TOWN OF DISCOVERY BAY CSD

October 27, 2008

RE: Town of Discovery Bay Community Services District Tentative Order Review

Attachment B – Map

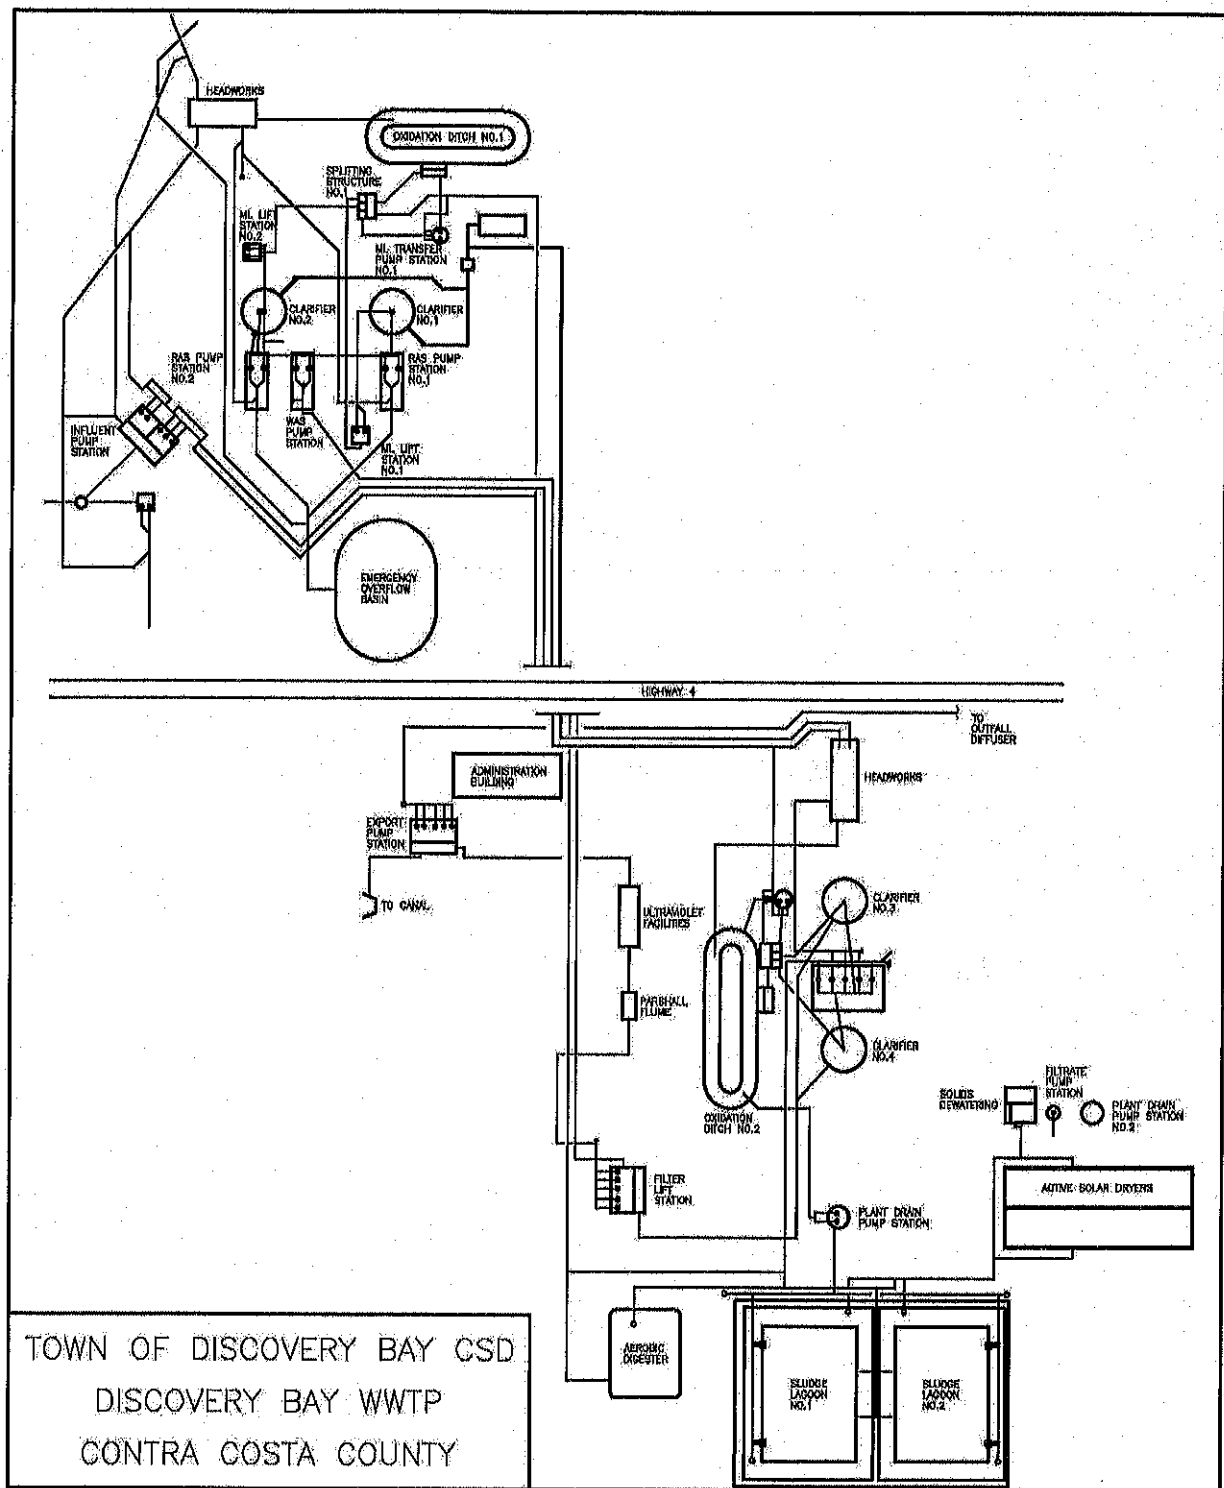
Attachment B - Map: Per our previous comments, the Attachment B-Map included in the Tentative Order is out-of-date. A more accurate Attachment B Map is enclosed as Attachment B to this letter.
